**ORDINANCE NUMBER 2016-09**

**AN ORDINANCE OF THE TOWN OF PARADISE VALLEY,  
ARIZONA AMENDING THE PARADISE VALLEY ZONING  
ORDINANCE, Article XXII, HILLSIDE DEVELOPMENT  
REGULATIONS**

Section 1. Article XXII, Hillside Development Regulations, Section 2200- 2209 are hereby  
amended (with deletions shown as ~~strikethroughs~~ and additions shown in **bold type**):

**FIGURE ~~2~~1 – HILLSIDE DEVELOPMENT AREA**

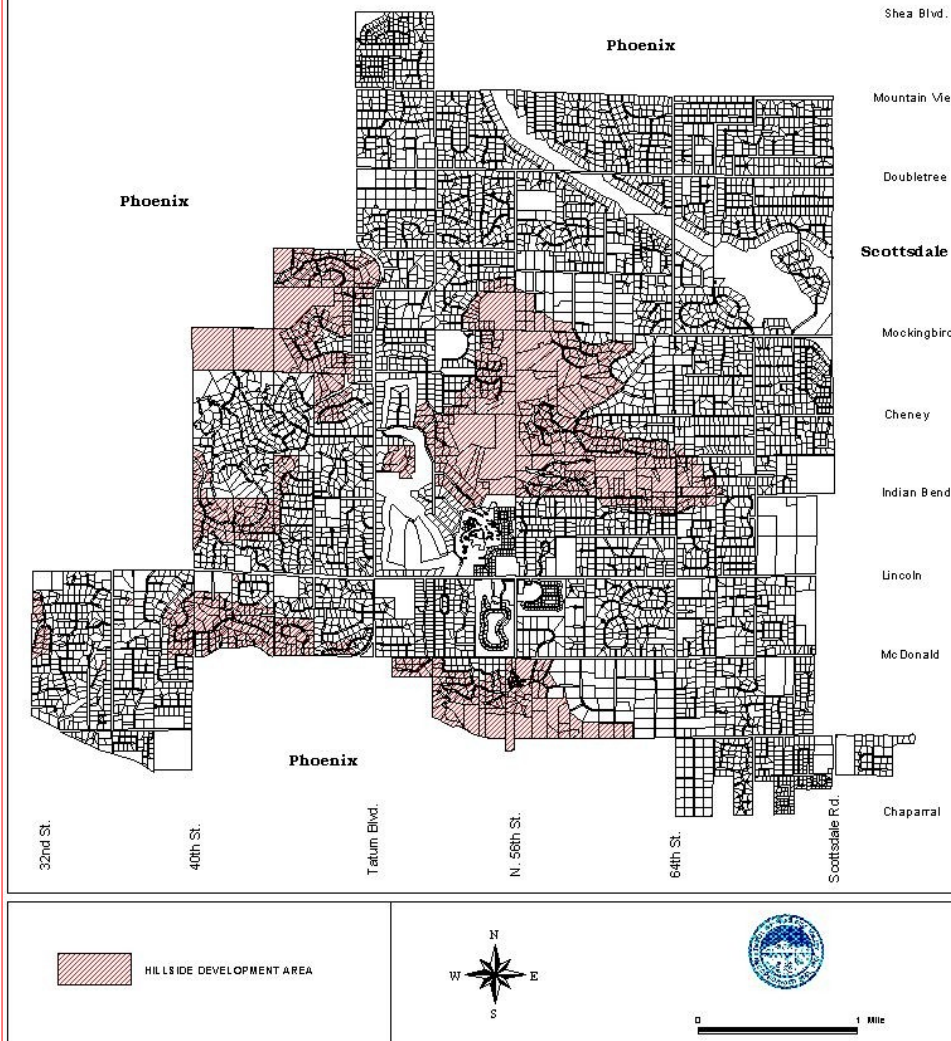
**Comment [GB1]:** Identify Process to Update Map with any properties removed from Hillside or added to Hillside

**FIGURE 3 — PRIMARY RIDGE LINE DESIGNATION**

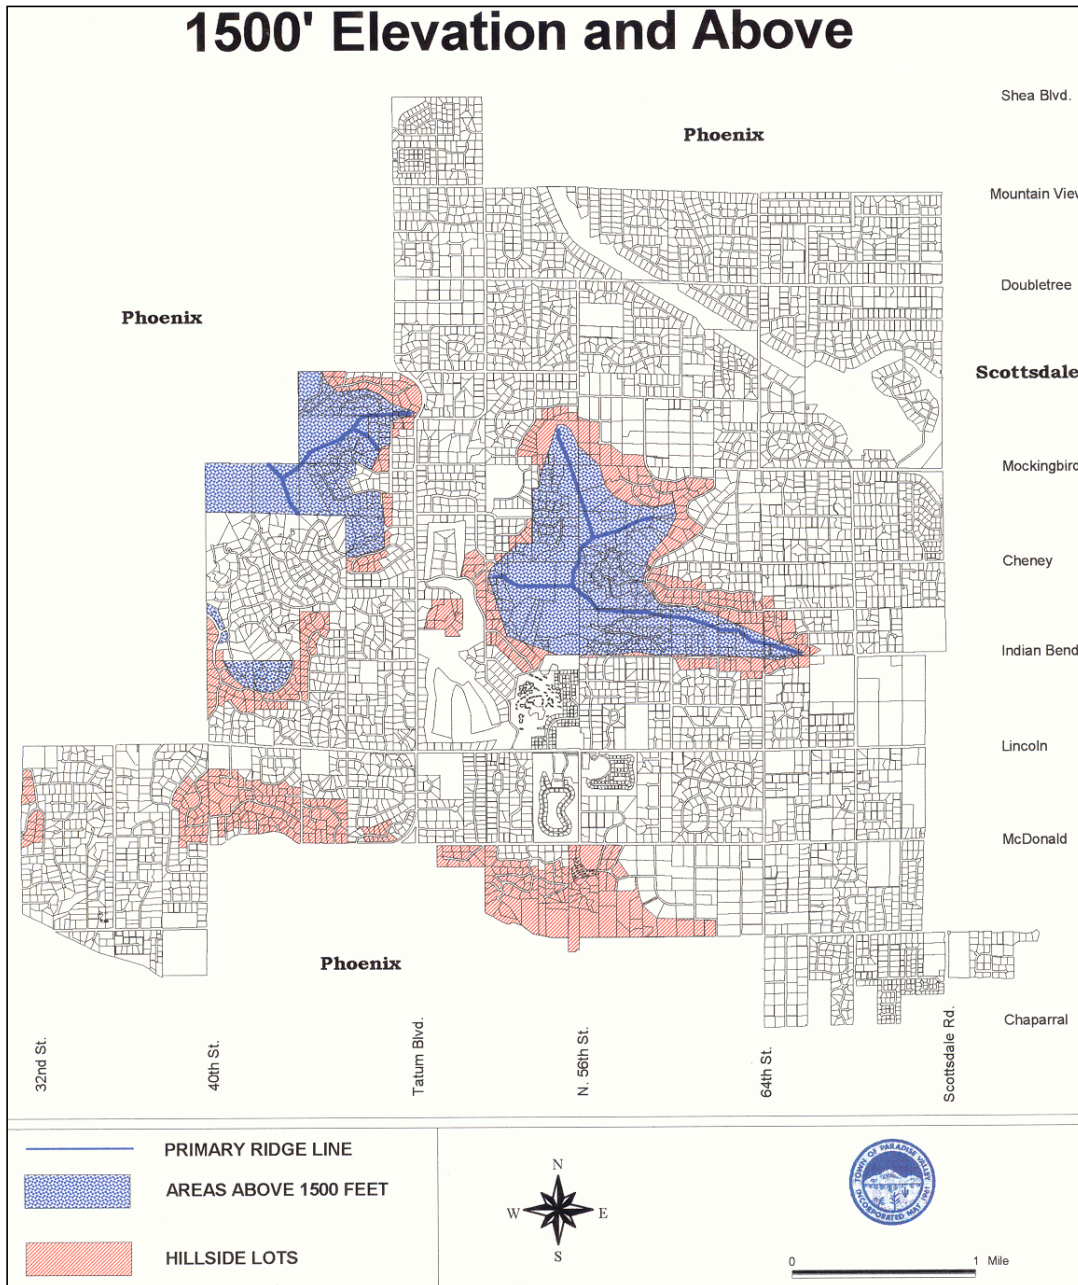
**Comment [GB2]:** Figure 3 Moved after Definition Section on Page 9

**FIGURE 5 – BUILDING HEIGHT IN HILLSIDE**

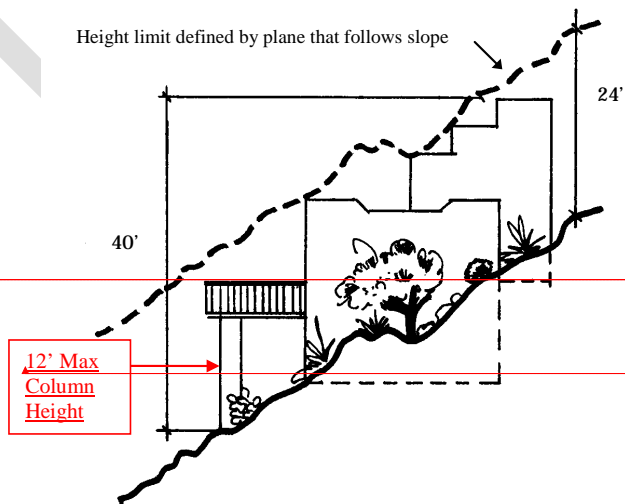
Comment [GB6]: Figure 5 to be updated to reflect these edits.

Comment [GB7]: Update Figure 5 to clarify measurement of 40' maximum height limit.

**FIGURE 7 - HEIGHT FOR A CANTILEVERED ELEMENT**

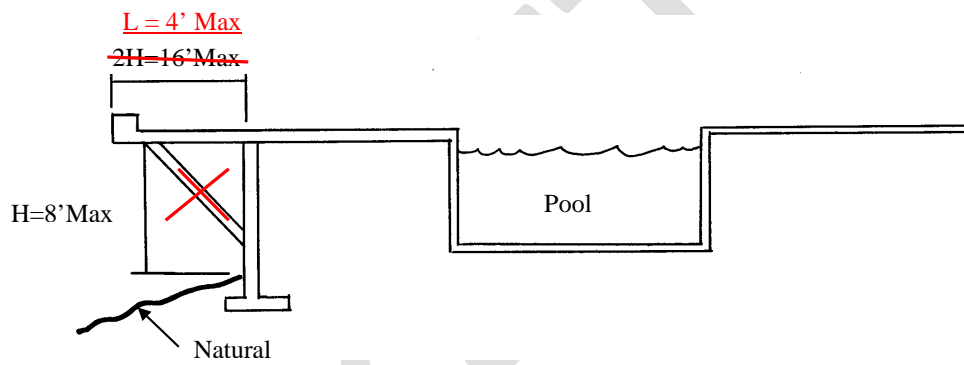
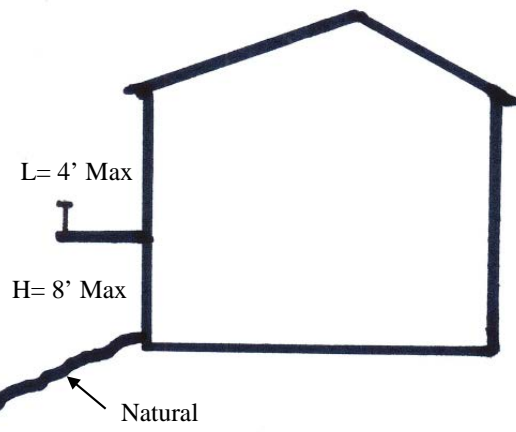
**Comment [GB8]:** New figures to be added to the code to illustrate these scenarios.

**Comment [GB9]:** Remove support from illustration and change horizontal to 4' max on Figure 7.

**FIGURE 8 –TERRACED VERTICAL RETAINING WALLS**

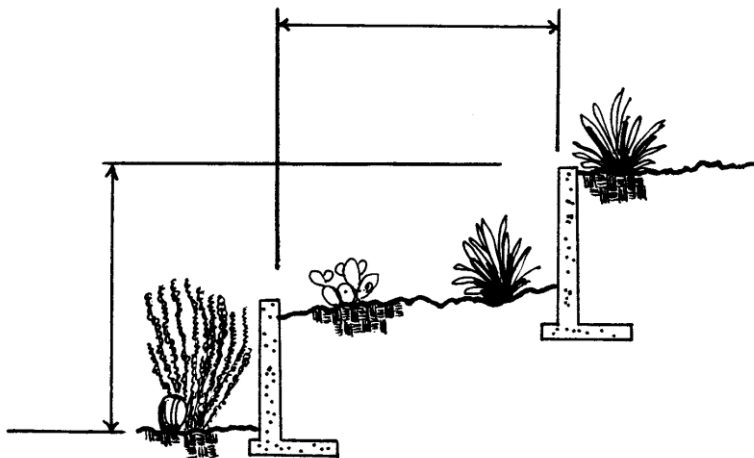
**Comment [GB12]:** Relocate Figure 8 below the text of 2207.VI.1.e.
